142.2.4.4 Transmit Interleaving

Figure 142-1—Information Bit De-Interleaver

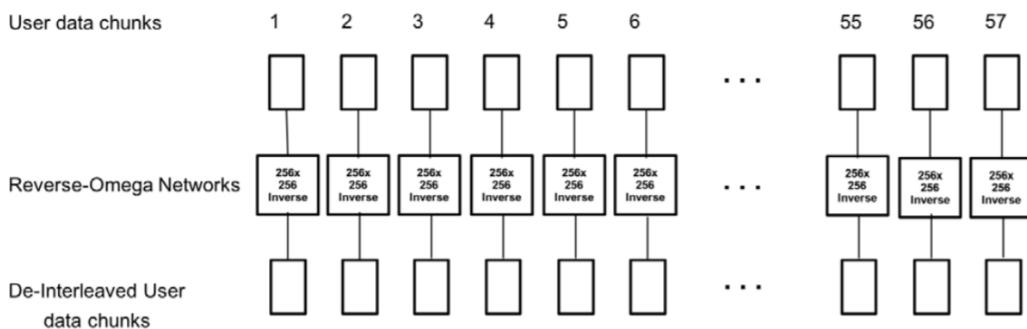
The information bit de-interleaver consists of 57 local de-independent Reverse-Omega (R->L) networks of size 256-by-256. As 256 as illustrated in Figure 142-1 these local interleavers are realized by 57 independent reverse omega networks. The information bits after zero padding are divided into 57 data chunks, and each data chunk has 256 bits, which is sent to one of the 256-by-256 omega Reverse-Omega (R->L) networks.

Figure 142-4—Parity Bit Interleaver

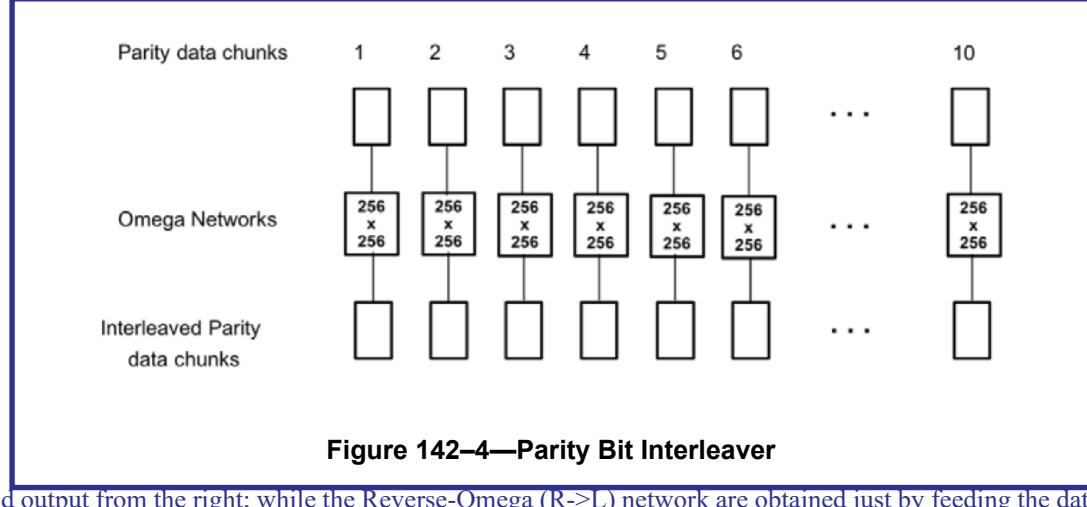
The first ten parity bit interleaver consists of 10 independent Omega (L->R) networks (see Figure 142-4). Each 256-bit parity-check bit segments are desegmented and sent to one of the 256-by-256 Omega (see Figure 142-4 L->R) using an eight stage 256x256 reversed omega network, where each segment has its own seed. These local interleavers are realized by 12 independent omega networks. Because puncturing length is fixed (512) and 512 bits make up of two whole data chunks, the last two parity omega networks are by-passed. In implementation, the parity bit interleaver consists of 10 omega networks.

Figure 142–5—Omega Network 256 Interconnection Network

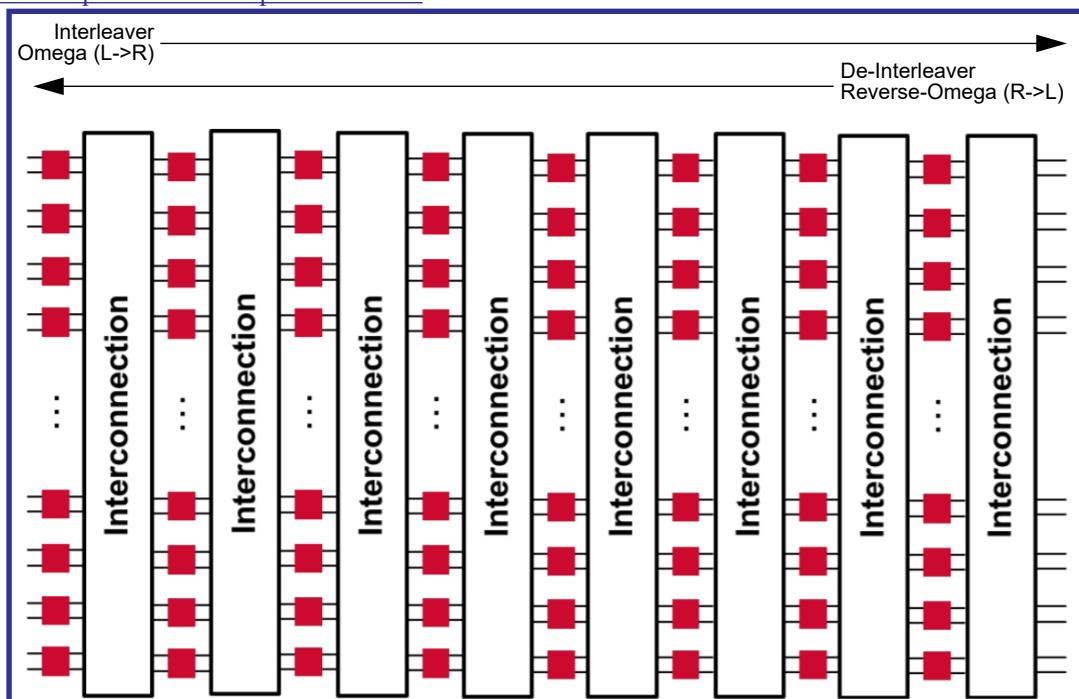
Note that the interleaver (Omega L->R) and de-interleaver (Reverse-Omega R->L) are just reverse permutations of each other. To clarify, with the Omega (L->R) network architecture data is input from the left side

and output from the right; while the Reverse-Omega (R->L) network are obtained just by feeding the data to the right side and output from the left side. This is illustrated in Figure 142-5 where each omega network is

made of an interconnection network with 8 stages of switches, each stage has 128 switches, and each switch has two inputs and two outputs as shown.

Figure 142–6—Example 8x8 Omega Network with a given switch programming

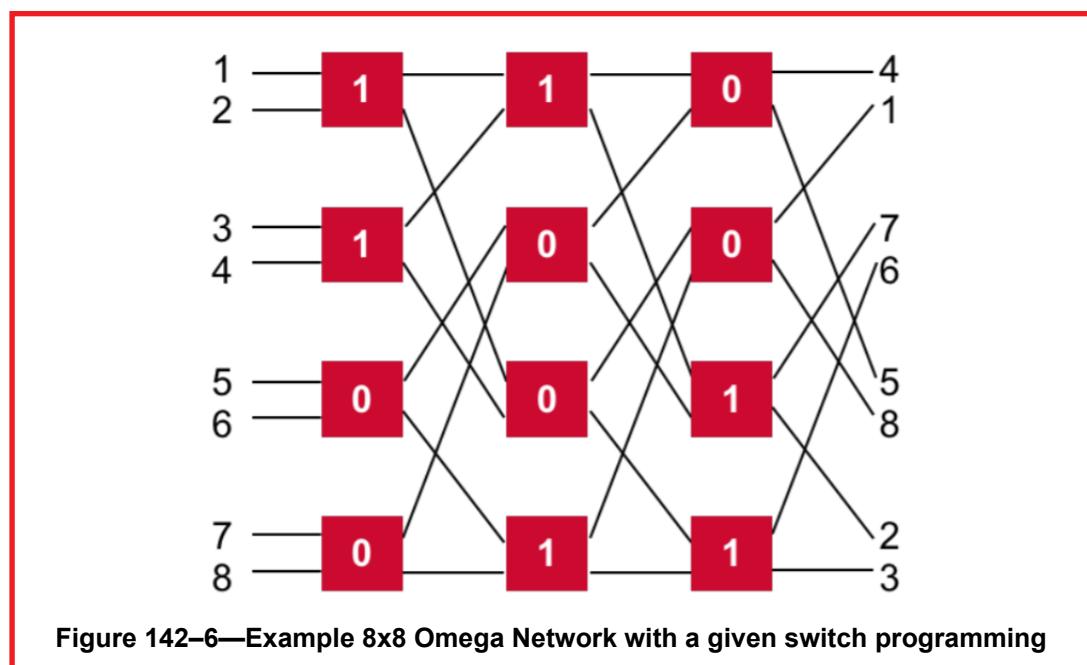
~~As an example, Figure 142–6 illustrates an 8-by-8 omega network with interconnections of 3 stages of 4 switches; and for a given switch programming, how the inputs are mapped to the output.~~
